Design Review Committee for SPI-9 SAP Application - Project Summary Letter

Project: 99 West Paces (Restaurant) Address: 99 West Paces Ferry Rd NW Atlanta, GA 30305 Project Area: 3,576 SF Interior Conditioned Area (+744 SF Kitchen Mezzanine) Building Height: 12 Story High Rise, Tenant Space Height is ~18'-0"

Design Team Response to DRC Recommendations:

FENESTRATION CALCULATIONS : EXISTING FACADE SOUTH FACADE AREA - 5,963.4SF FENESTRATION AREA - 3,894.1SF PERCENTAGE FENESTRATION - 65.3%

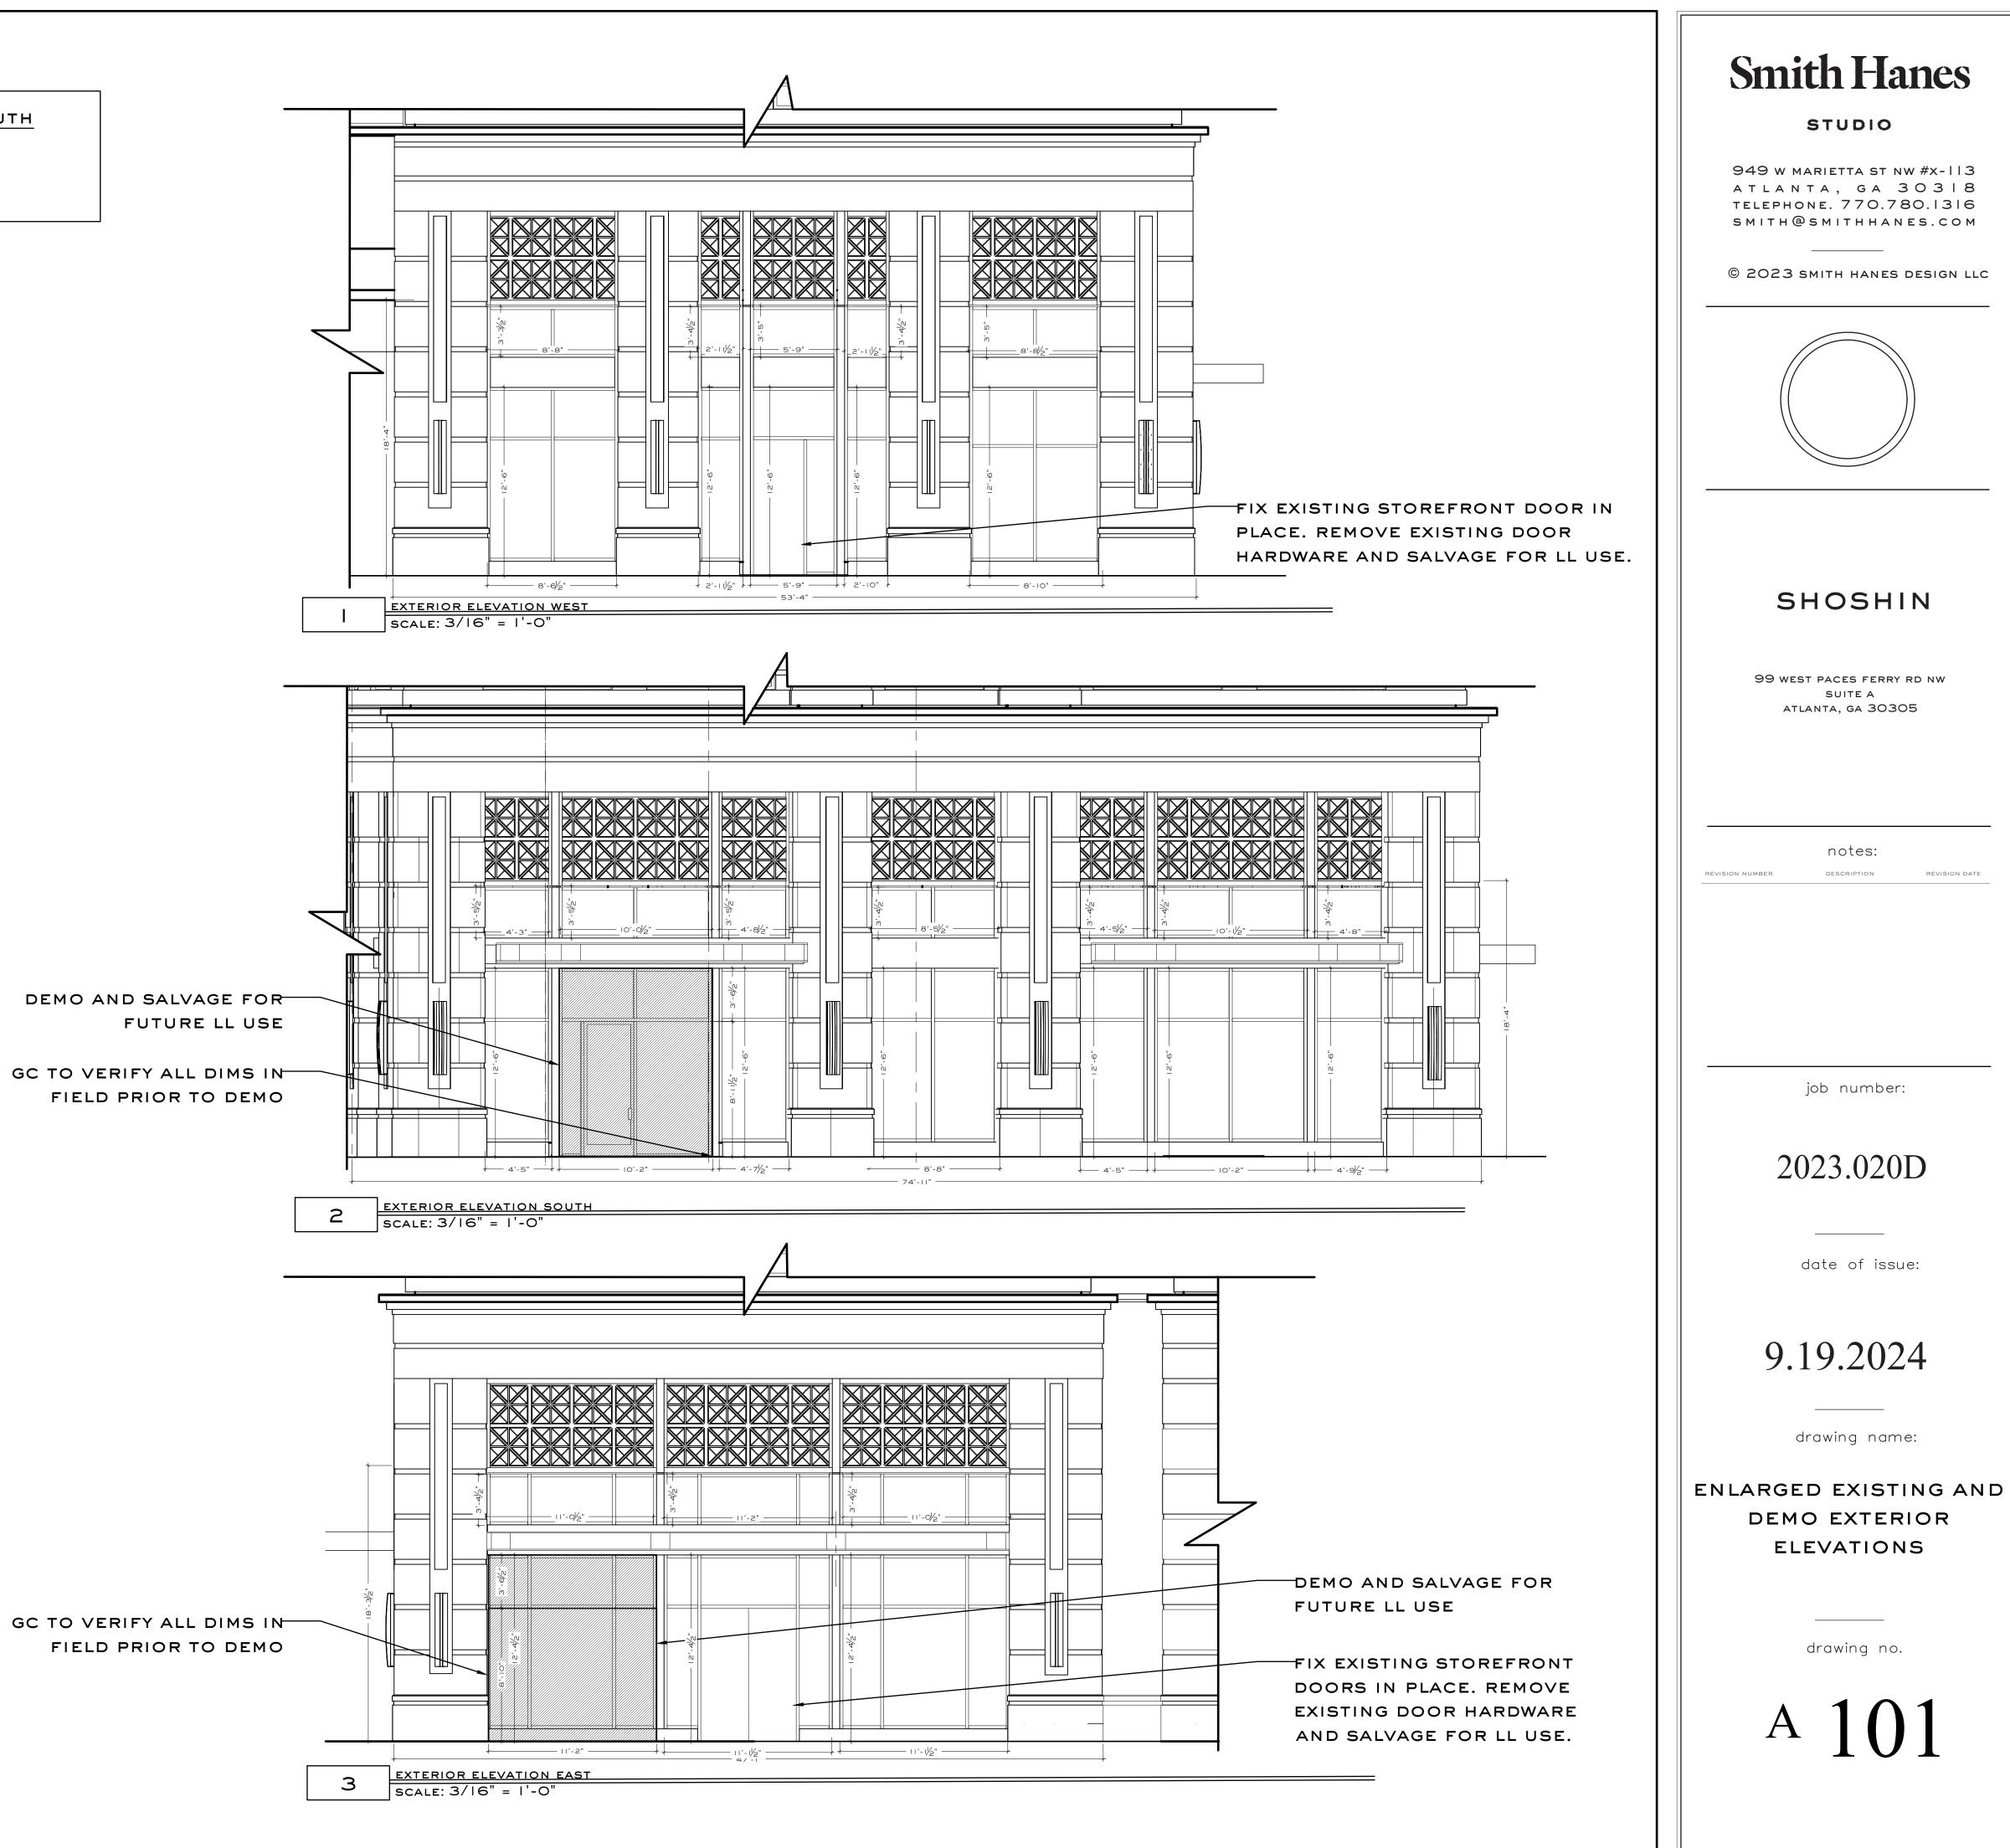
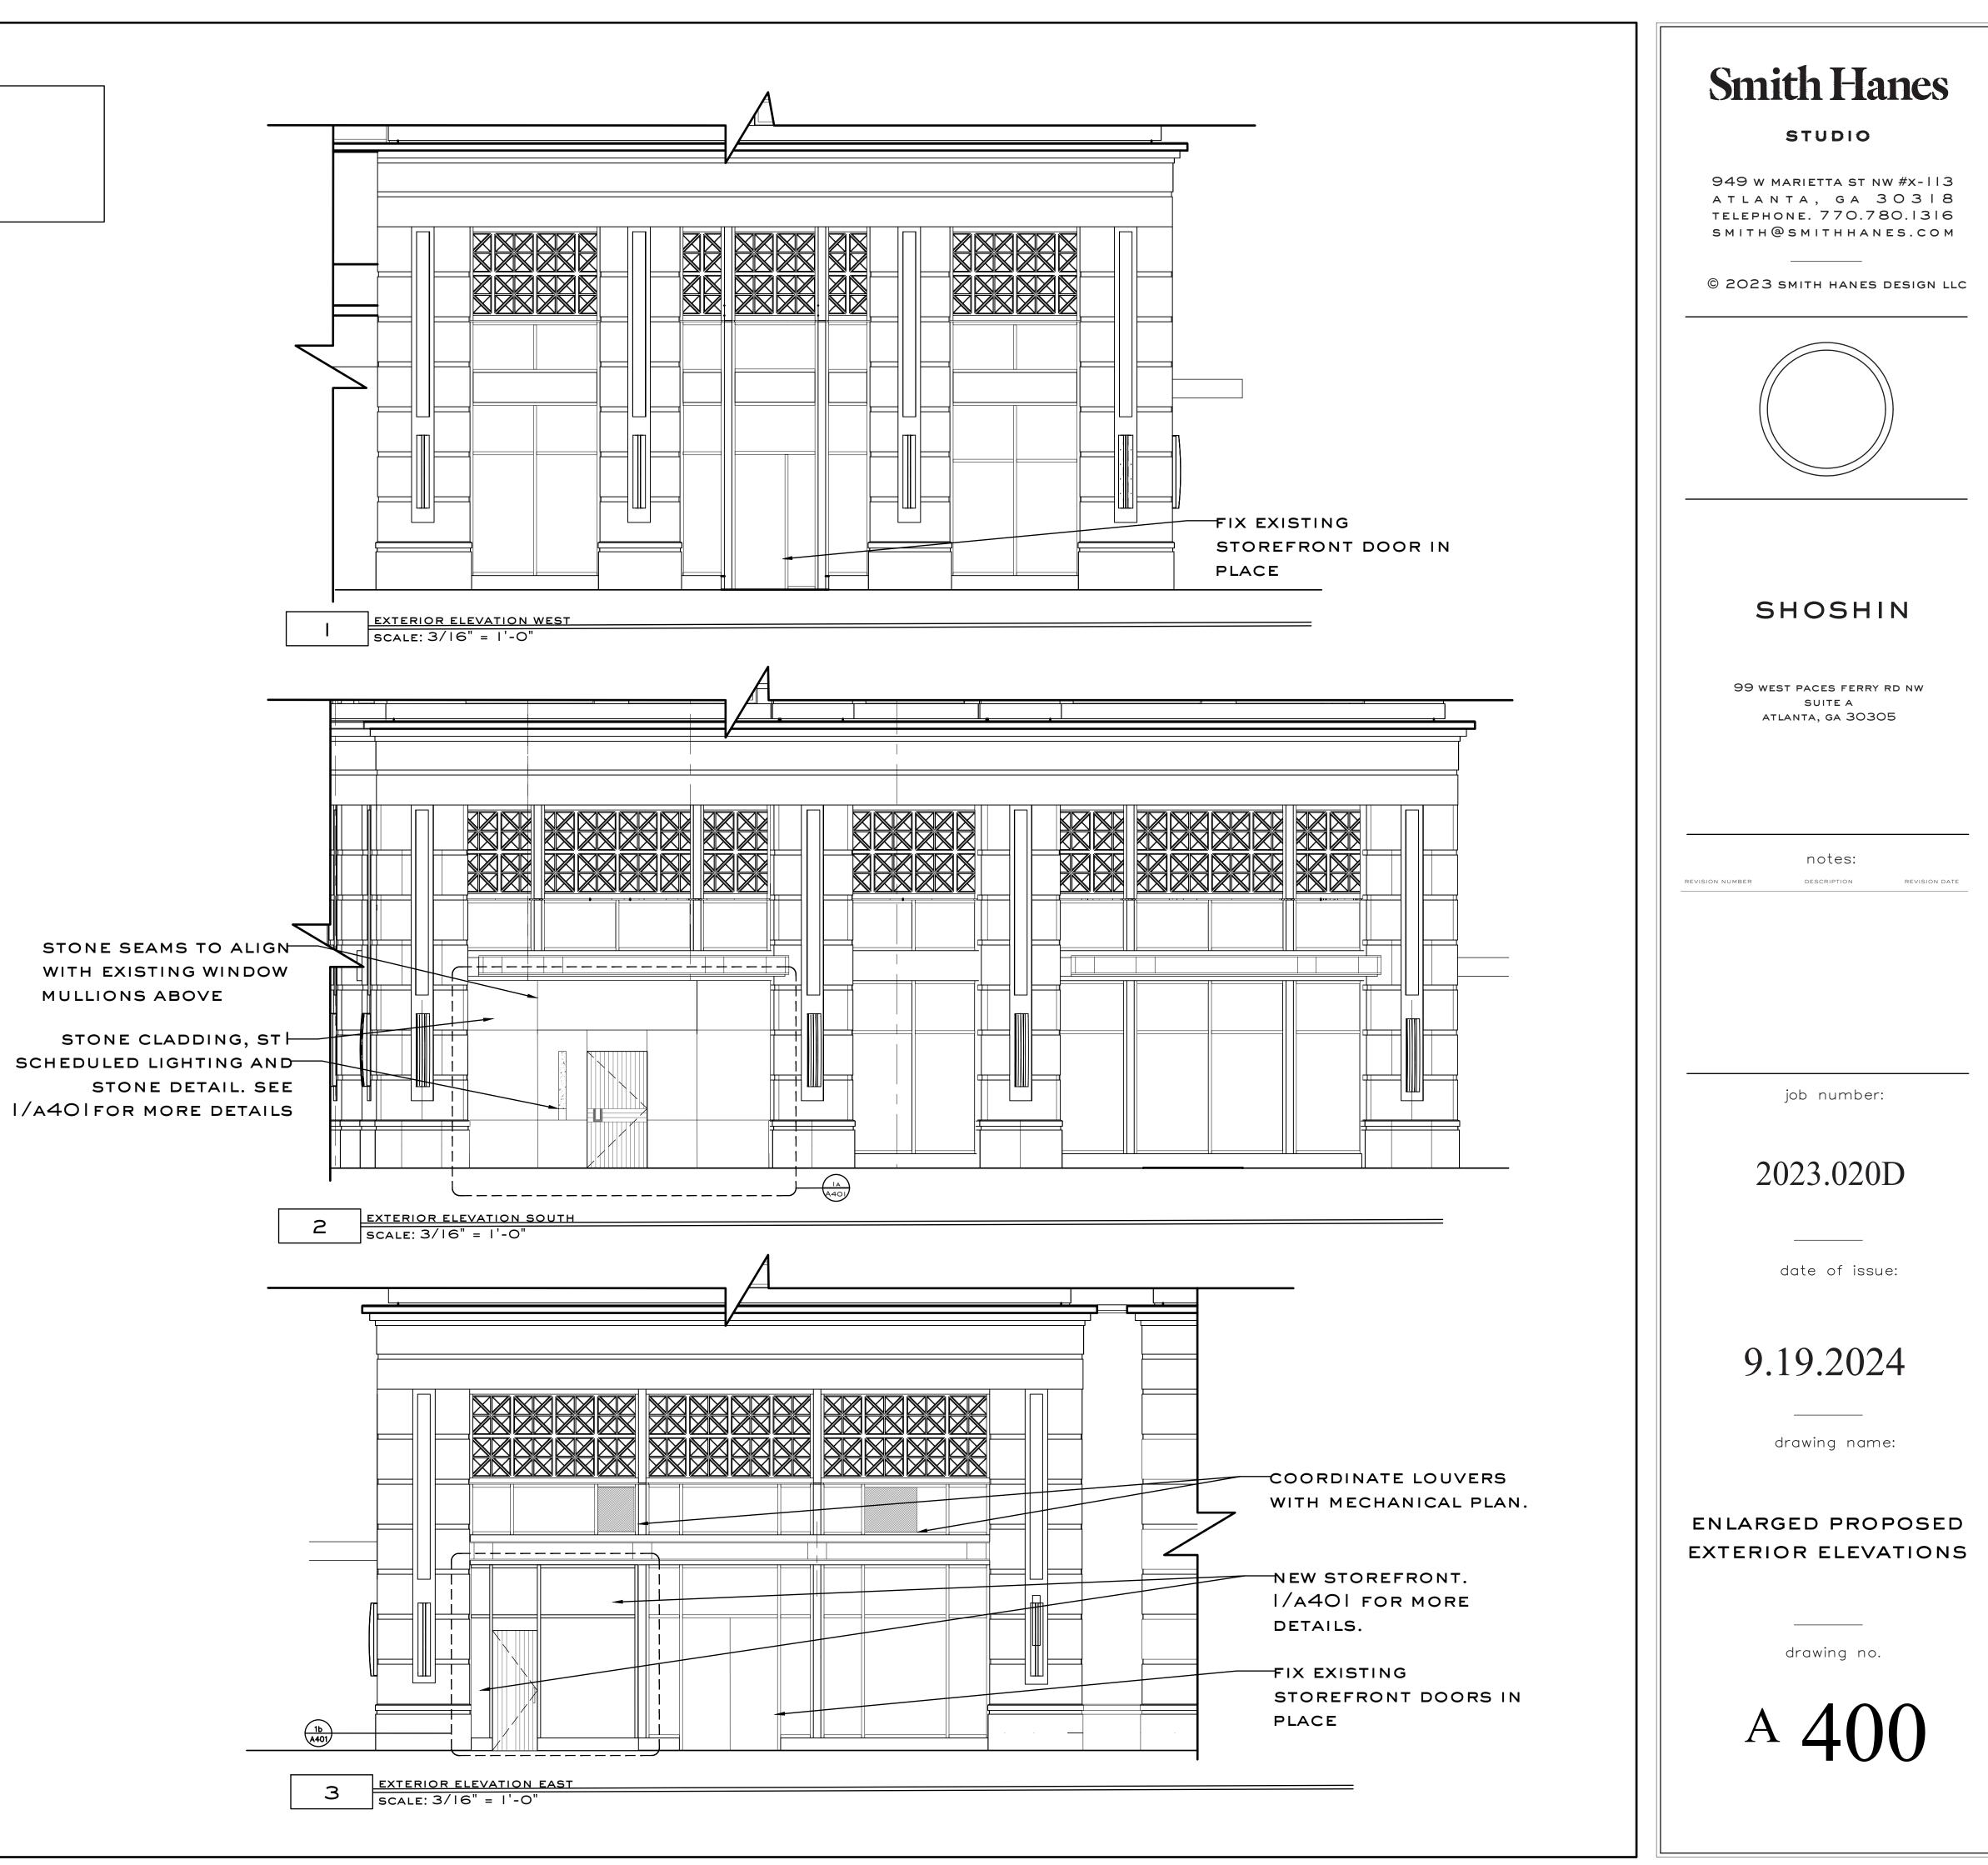
We are Requesting a Variation from the Atlanta zoning code 16-18I.017-5 fenestration requirement of 65%. We are covering 239 sf of storefront / fenestration, which calculates a 4% decrease in fenestration from 65.3% down to 61.3% for the length of the street frontage along West Paces Ferry at ground level.

Sec. 16-18I.017.5: Fenestration including all window and door openings shall be provided at the sidewalk level for a minimum of 65 percent of the length of the building for nonresidential uses. The code requires 65% fenestration along West Paces Ferry Road and the approved SAP 18-131 which allowed for construction of the full building met this requirement at 65.3%. While this SAP will only modify a portion of the full street frontage, fenestration in the affected area will drop to zero and significantly reduce the overall fenestration to well below code requirements.

Recommendation: One of the major goals of the Special Public Improvement District regulation is to create a walkable community. Fenestration requirements are a key tactic to achieve this as they are intended to create an engaging pedestrian experience along the adjacent sidewalk by allowing passersby to see into the establishment. While the committee understands, the applicant desires to achieve an intimate feeling inside the space, the proposed approach, literally blocking out the windows, would set an undesirable precedent counter to the goals of the district. Therefore, the committee recommended the applicant revise their design, particularly as it relates to the treatment of the windows along West Paces Ferry that are not proposed to receive the stone and wood entrance treatment.

- Reconfigure the layout of the restaurant to allow for the remaining windows along West Paces to be converted into (retail) display windows that are internally illuminated and provide visual interest to pedestrians.
- 2. Establish an artistic, visually attractive installation on the street facing side of the proposed partition walls to provide an engaging pedestrian experience on the exterior of the space,
- 3. Retain the windows proposed to be converted to opaque glass and walled over in some manner to allow for pedestrians to look into the restaurant before 5p.

For Resubmission and Response to the DRC Recommendations above, we are submitting revised design drawings. The change to the design aligns with the DRC Recommendation #3.

Our revision to the design proposes to keep the existing storefront and visibility into the space from the sidewalk for the central portion of windows. We have removed the interior partition and will plan for views in and out at this section. The portion of windows at the far right / East side of our space along West Paces Ferry will have some custom wine storage and cooling equipment that will not allow for any views to the interior of the space. Our design intent is to keep those windows in the design as opaque.

FENESTRATION CALCULATIONS : FACADE SOUTH FACADE AREA - 5,963.4SF FENESTRATION AREA - 3,533.1SF PERCENTAGE FENESTRATION - 59.2%
